**COUNTY OF SAN MATEO  
PLANNING AND BUILDING DEPARTMENT**

**SUBJECT:** Consideration of a Minor Subdivision, pursuant to Section 7000 of the County Subdivision Regulations to subdivide one legal developed 40,096 sq. ft. parcel into two parcels and retain the existing single family residence. The project is located 607 Handley Trail in the unincorporated Emerald Lake Hills area of San Mateo County.

County File Number: PLN 2017-00540 (Sowers)

SHEET NO.  
**T4.0**  
4 OF 11 SHEETS

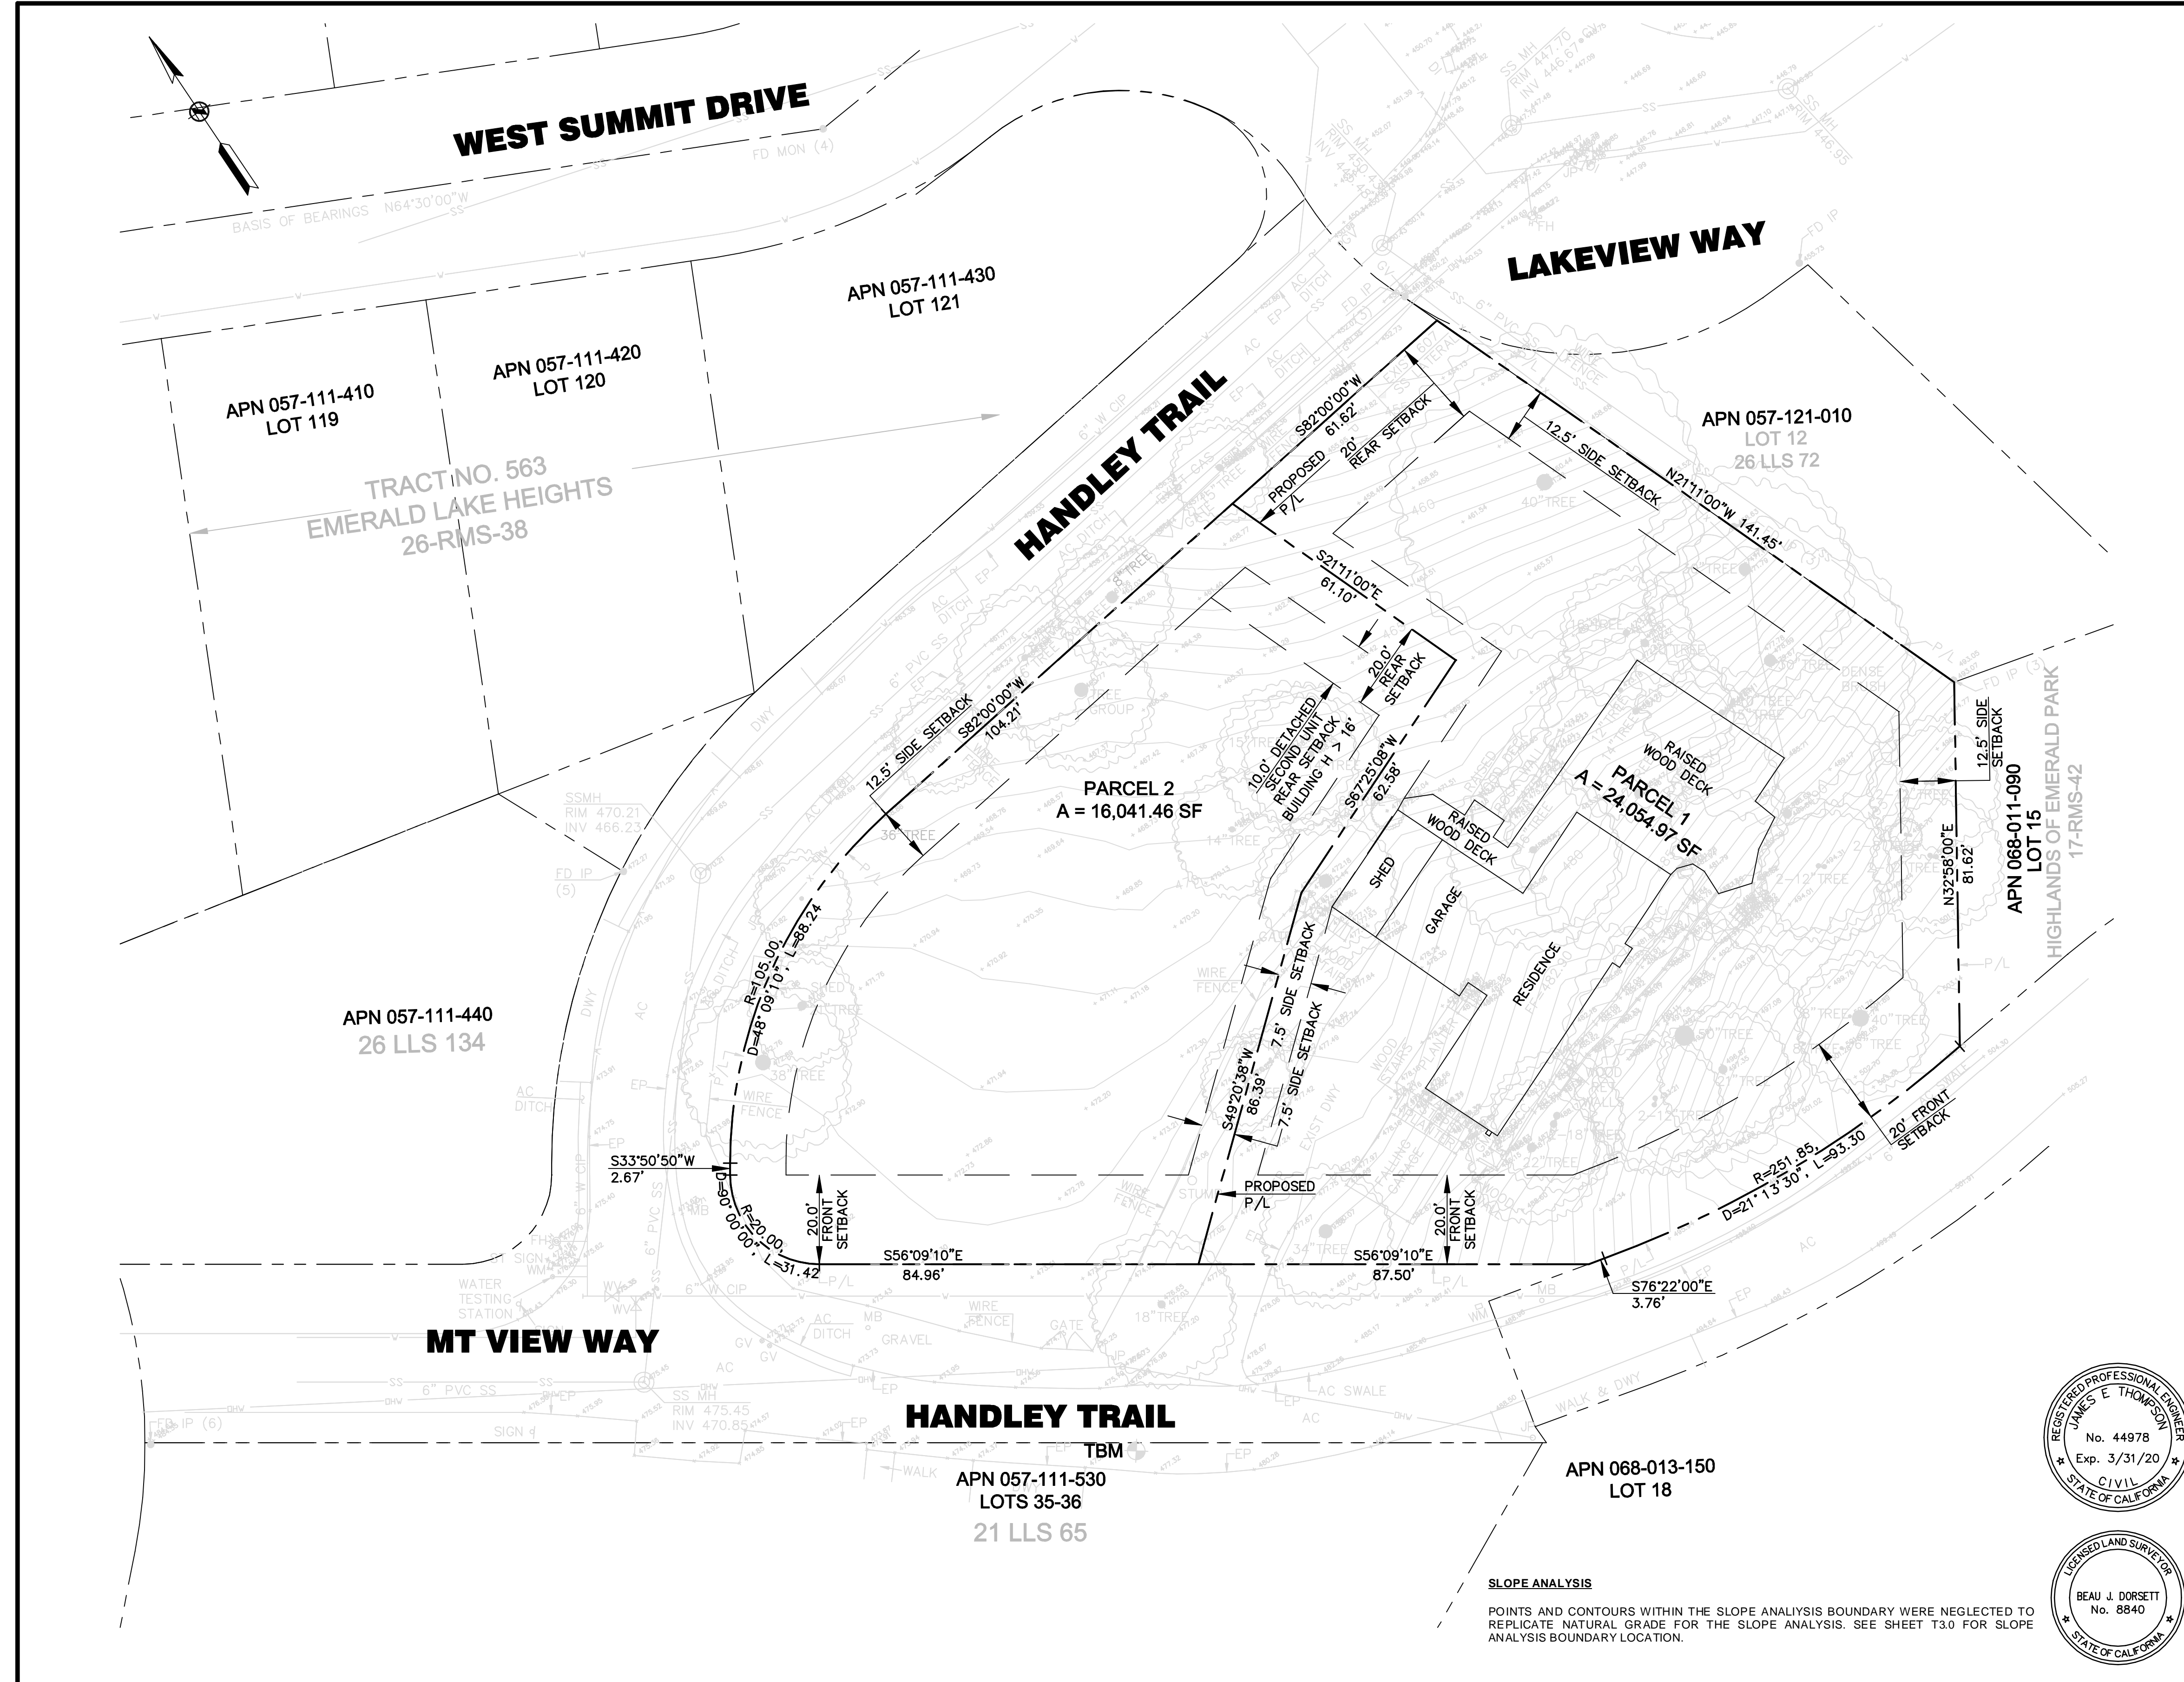
28. The tentative subdivision map (Sheet No. T4.0) indicates that the property is proposed to be subdivided into two parcels. The Sewer District records indicate that an assessment fee was paid for one (1) sewer connection at the time when the sewer collection system was constructed (Assessment No. 294), which means the property has only one sewer connection. The Sewer District will allow the additional connection for the proposed new parcel provided that all associated fees are paid. The Sewer District will require the applicant to purchase an additional sewer connection and obtain all appropriate permits for the installation of the connections. The fees for a new sewer connection will be calculated based on the information submitted prior to final approval of the building plans.

SHEET NO.  
**T6.0**  
6 OF 13 SHEETS

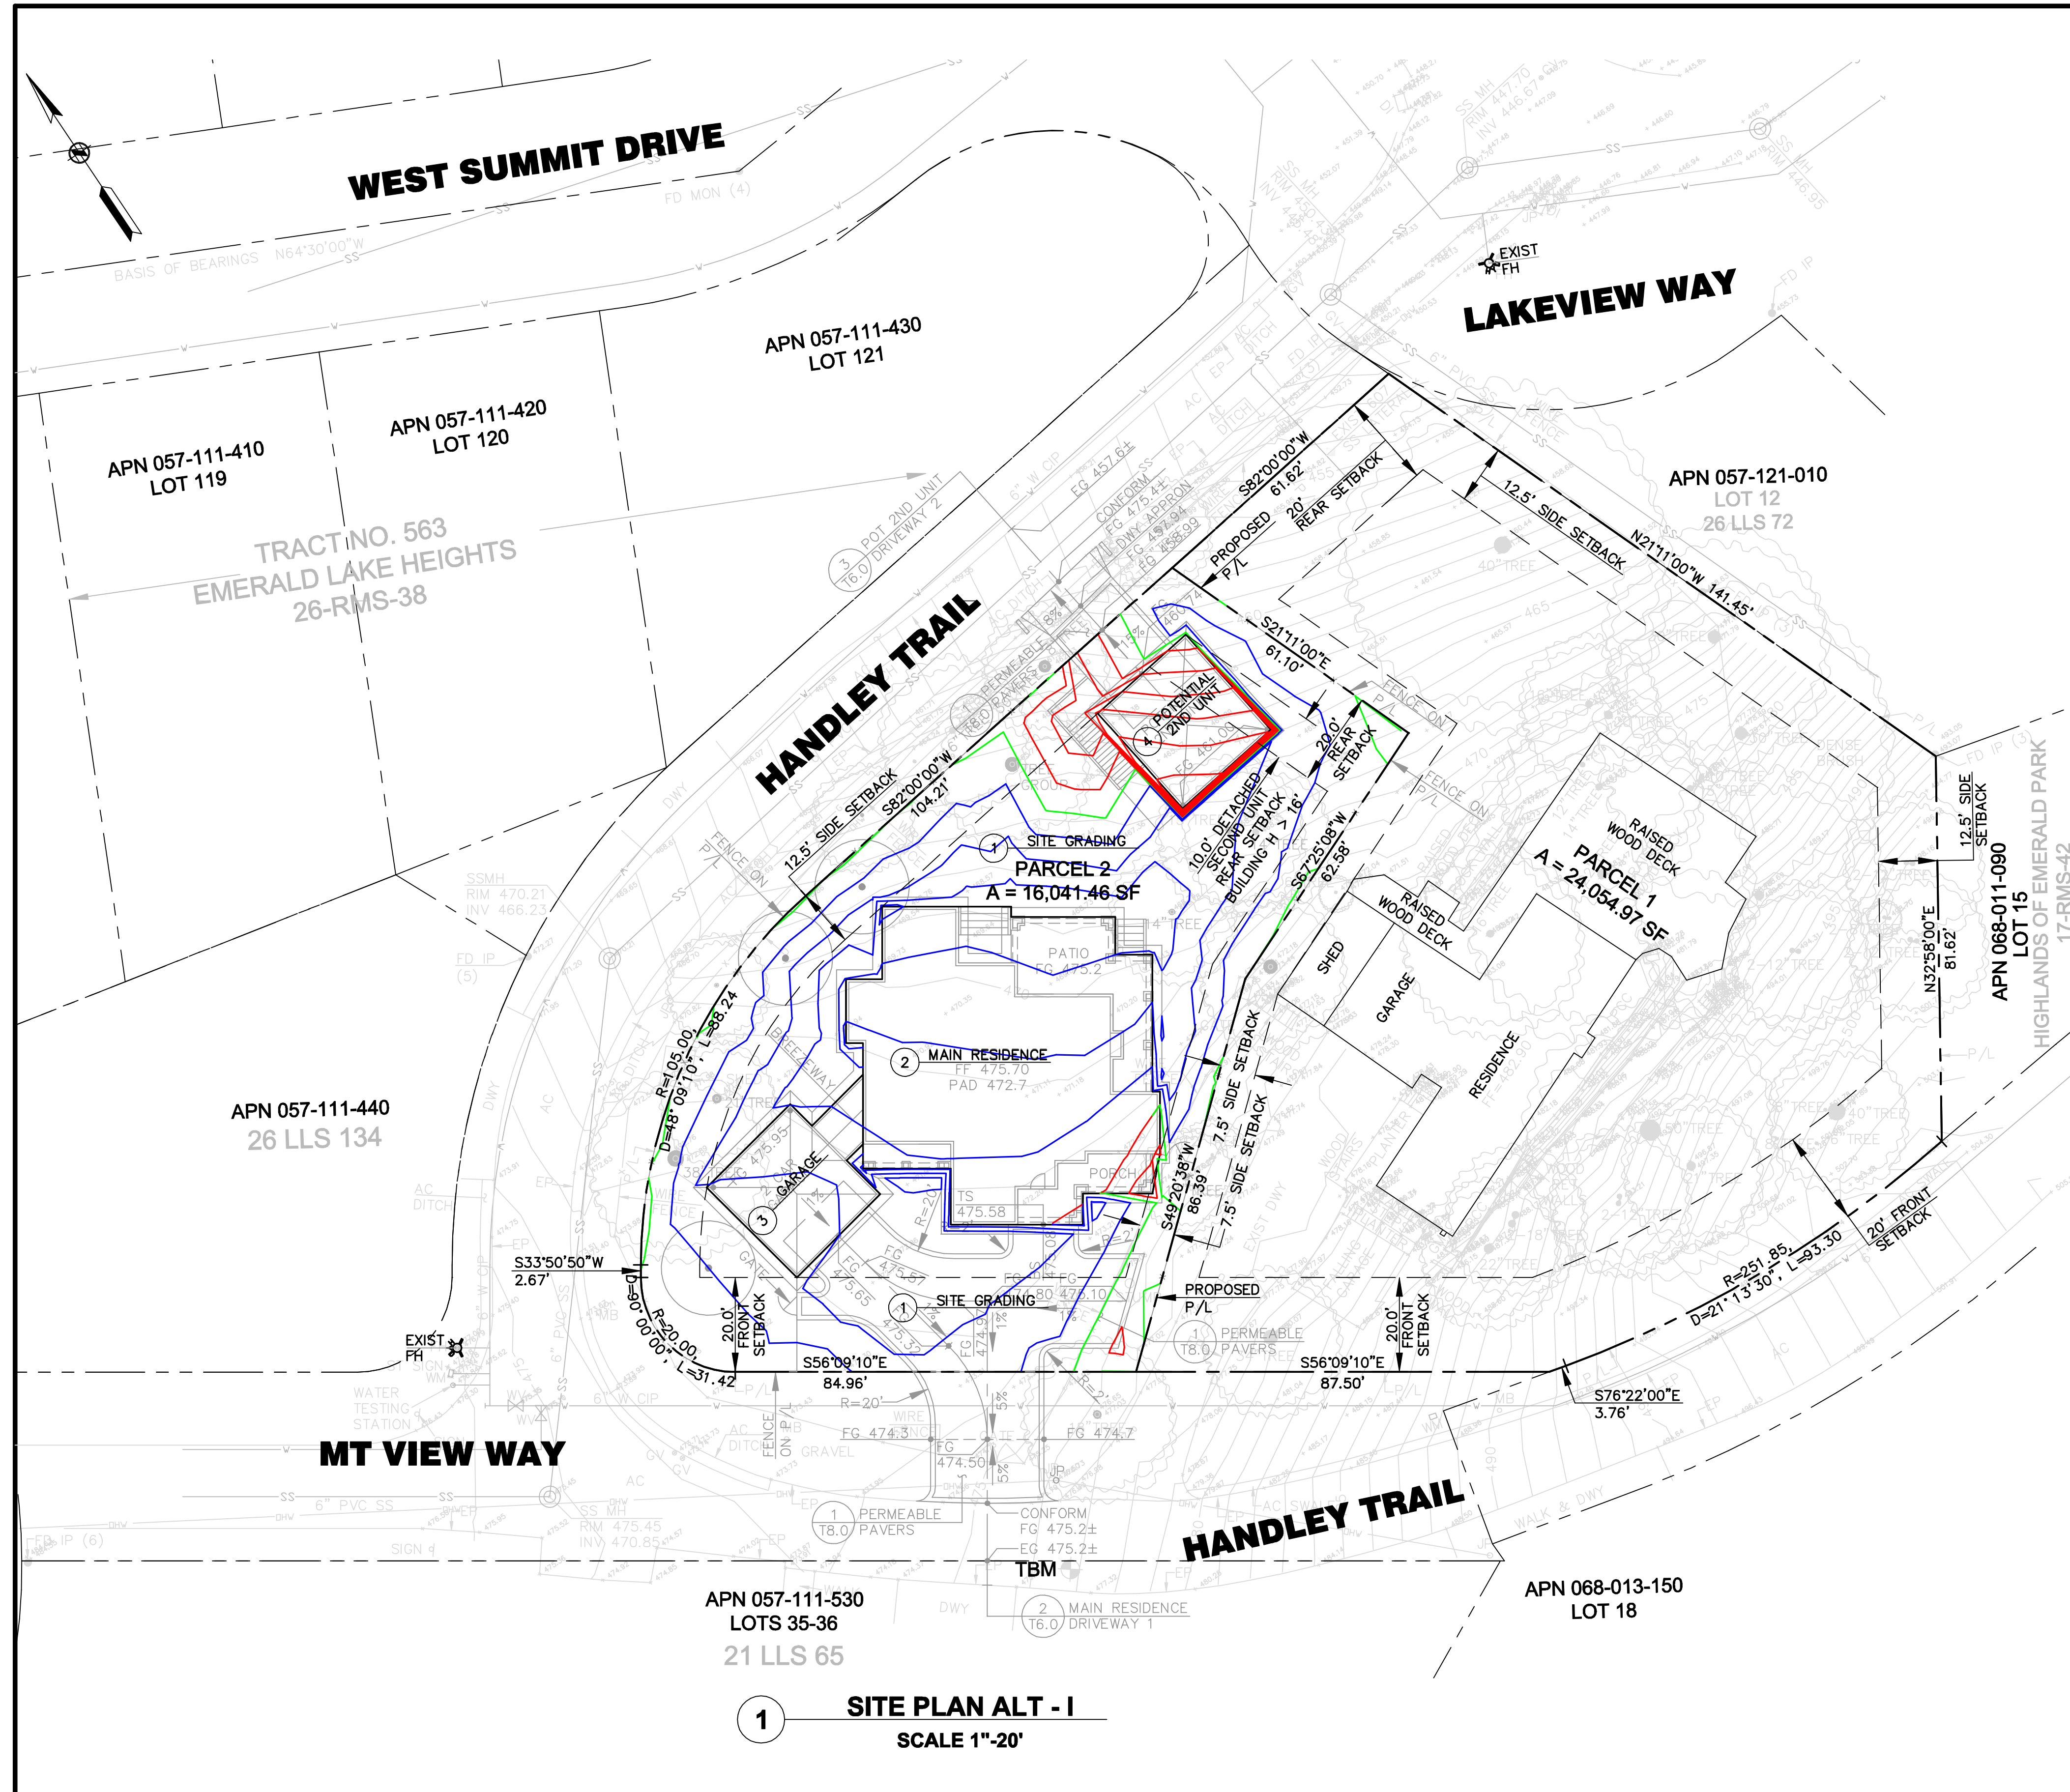
21. Upon submittal of a Design Review Permit the applicant shall revised sheet T-6 to: (1) remove the pervious pavers shown in the right-of-way and replace the pavers with asphalt concrete 2" AC over 6" Class II AB, and (2) remove any curbs, landscaping etc. shown in the right-of-way. The applicant shall also revise sheet T-7 to remove the drainage line shown in the right-of-way and replace with a bubble box or other appropriate stormwater feature on private property.
